Polythermal conditions in small glaciers in the Swiss Alps

Response to Referee #2

27 August 2026

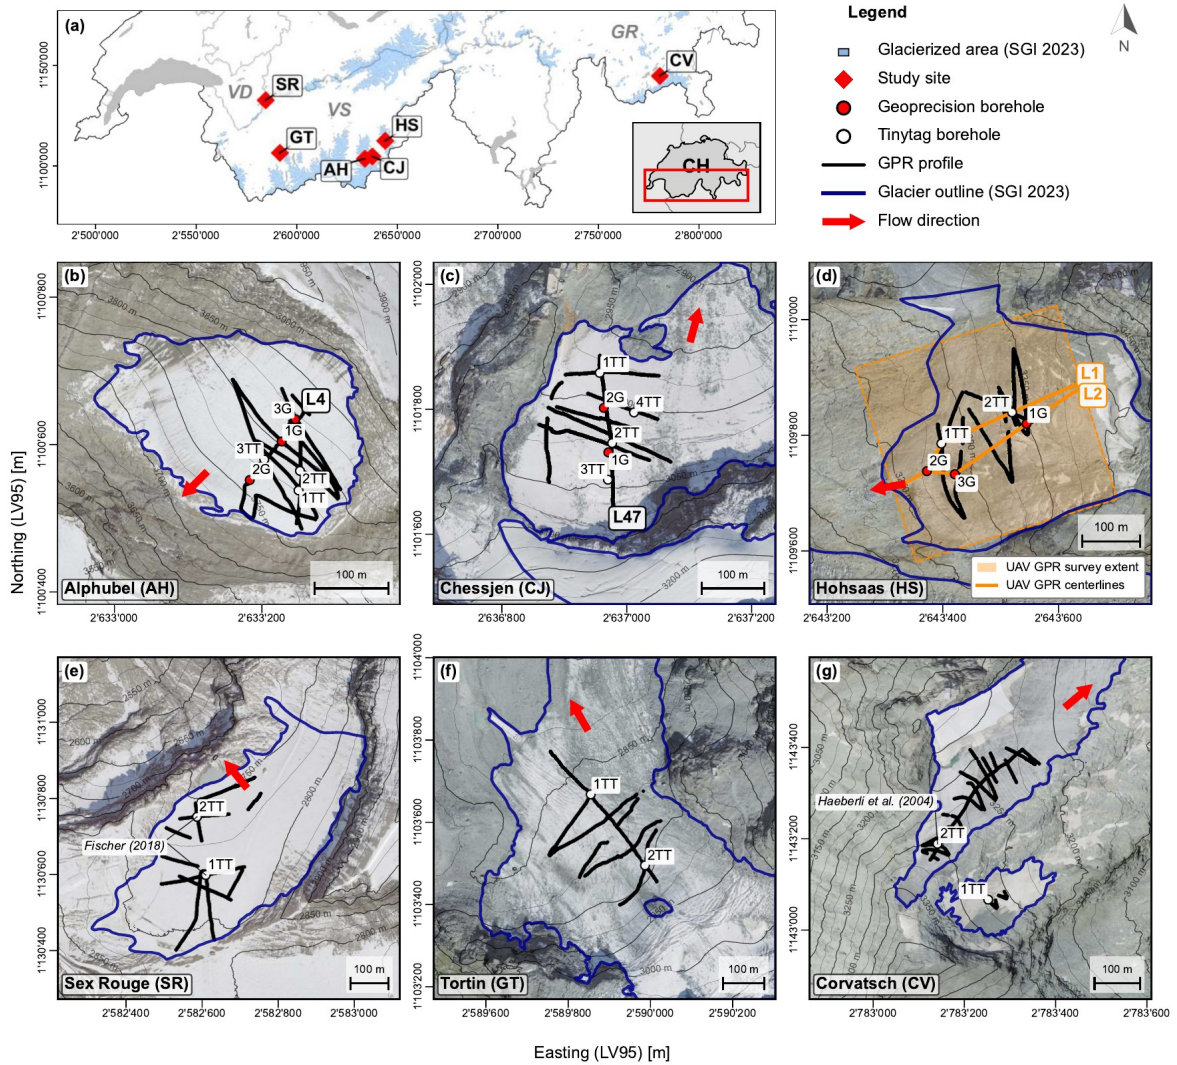
R2.C13 (Figure 1)

I appreciate some scale is apparent given the gripping of panels b-g, however for easier comparison please could you add a scale bar to each panel.

Response: We agree and have added a scale bar to each panel of Figure 1, placed in the lower right of each panel, to allow easier comparison between the sites.”

Changes in the manuscript: Added a scale bar to the lower right of each panel (b–g) of Figure 1.

Figure 5, revised (Fig. 6 in the discussion paper). Englacial temperature structure and radar reflectivity along Alphubel profile L4.

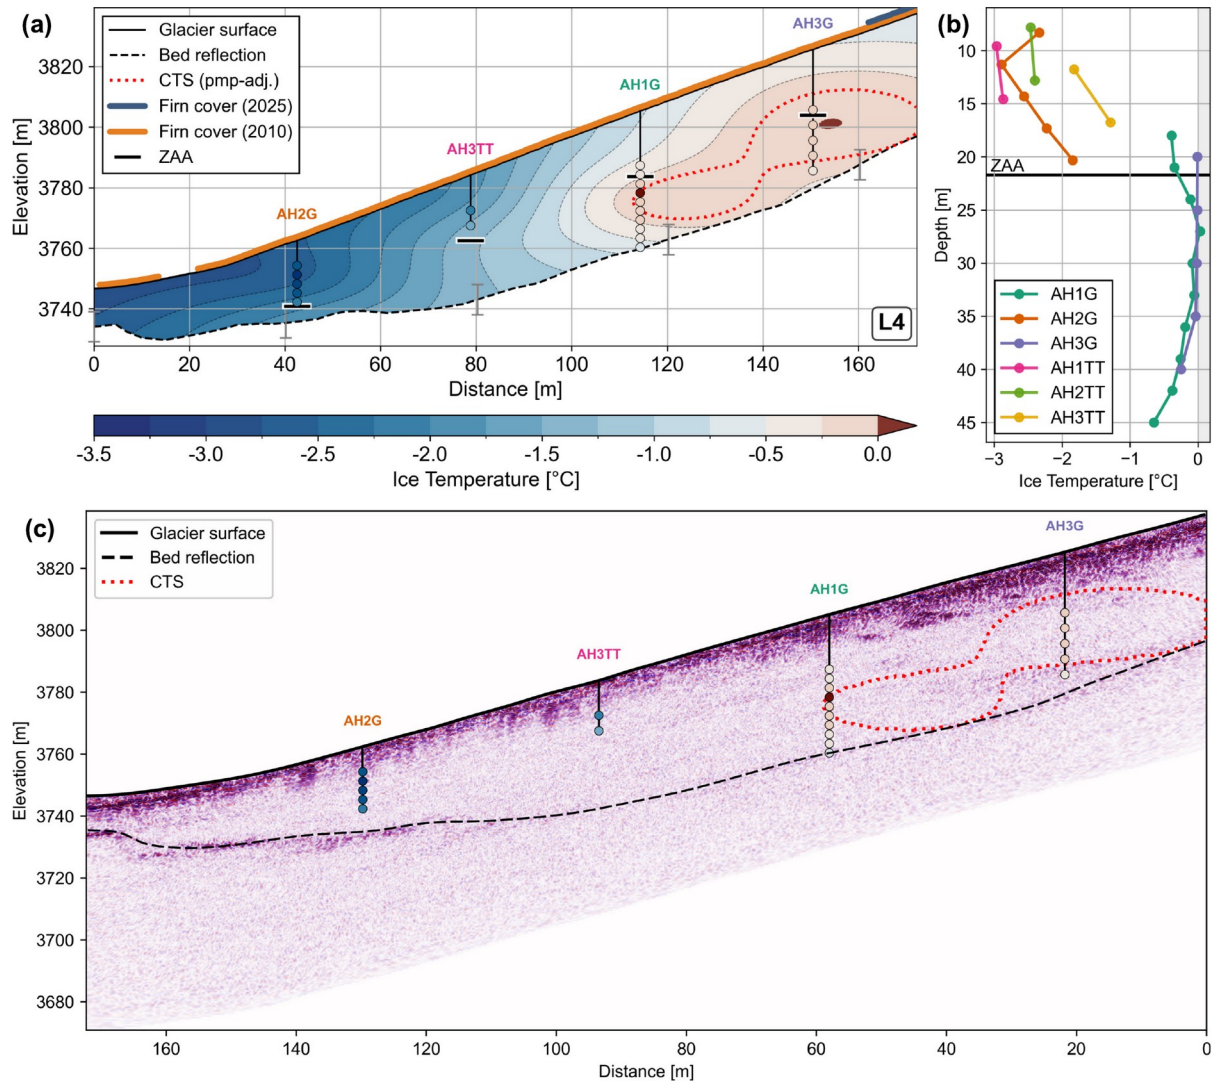
Following my above suggestion, I would advise integrating Figure 4 within Figures 6-8 for the relevant glaciers. This would allow us as the reader to see how the temperatures have evolved at depth over a season and how this then can be interpreted to the polythermal structure described. I also feel the symbology of these figures could be reworked to clearly distinguish what is a scale and what is a location/depth.

R2.C29 (Figures 6-8)

At present I am finding these figures hard to follow and my main questions are: • Is the black dashed line in panel A and C the isotherm or glacier bed, this is unclear when compared to panel B • I would invert your temperature scale so it increases as it moves right across the page, this is more standard and coincidentally is similar to the profiles drawn in panel A which will make it easier to follow. • I cannot see seasonal changes in the figure given that it is average, consider integrating Figure 4 within this as this will make the changes clearer • Symbology between each panel could be more distinct.

Response: We appreciate this suggestion, and reworking these figures for clarity was one of the more substantial revisions we made. On the symbology, the reviewer is right that it was not always clear what encoded a scale and what encoded a location or identity, and we have restructured the figures with exactly that distinction in mind. Ice temperature is now shown consistently through a single temperature colour map, used both for the interpolated field and for the borehole markers in panels (a) and (c), so that colour always means temperature. The individual borehole profiles in panel (b) are instead distinguished using a separate qualitative colour scheme from ColorBrewer (Harrower and Brewer, 2003), chosen for maximal categorical distinctness, so that borehole identity can no longer be mistaken for a temperature. We have also given the glacier surface, bed reflection, and CTS distinct and explicitly labelled line styles, and the ZAA depth is now marked both in panel (a) and in panel (b), directly showing which depths are seasonally variable and which represent the longer-term thermal structure. On integrating the seasonal time series (Fig. 4) into these figures, we gave this careful thought, as we agree that linking the seasonal evolution to the polythermal structure is valuable. On balance, however, we felt that adding it would overload figures that are already information-dense, and the seasonal behaviour is developed in its own right in Sect. 4.1. To capture the reviewer's underlying intent, that the reader should be able to see which part of the profile is seasonal, we added the ZAA depth to panels (a) and (b), which now shows directly which depths are seasonally variable and which reflect the longer-term thermal structure. We hope this offers a good compromise between completeness and legibility.

Changes in the manuscript: Revised Figs. 6–8 (see the captions quoted under R1.C25): single temperature colour map across panels (a)/(c); qualitative palette in panel (b); ZAA marked in panels (a) and (b); grey band for temperatures above 0 °C. Fig. 4 not embedded.

Response: We have reworked all three figures (Figs. 6 to 8) to address these points. (1) We have removed the ambiguity around the dashed line: previously a dashed line denoted the 0°C isotherm in panel (b) but the bed

reflection in panels (a) and (c). We have replaced the dashed 0°C isotherm in panel (b) with a shaded grey band, so a dashed line now consistently denotes only the bed reflection throughout, and the panel legends explicitly identify the glacier surface (solid), bed reflection (dashed), and CTS (red dotted). (2) We have inverted the temperature axis in panel (b) so that temperature increases from left to right, consistent with the adjacent panels. (3) Regarding the seasonal changes, we have added the depth of zero annual amplitude (ZAA) both to panel (a), as ticks per borehole, and to panel (b), as a horizontal line, so that the reader can see directly in both views which depths are subject to seasonal variability and which are representative of the longer-term thermal structure. We would prefer, however, not to integrate the seasonal time series (Fig. 4) into these figures: they are already densely loaded, and the seasonal behaviour is presented and discussed separately in Sect. 4.1. Combining the two would, in our view, reduce rather than improve the clarity of both. (4) We have also made the symbology more distinct and consistent between panels, including a consistent spatial orientation between panels (a) and (c).

Changes in the manuscript: Revised Figs. 6–8 (captions quoted under R1.C25): grey band for temperatures above 0 °C and dashed line reserved for the bed reflection; inverted panel-(b) temperature axis; ZAA in panels (a) and (b); consistent panel symbology.
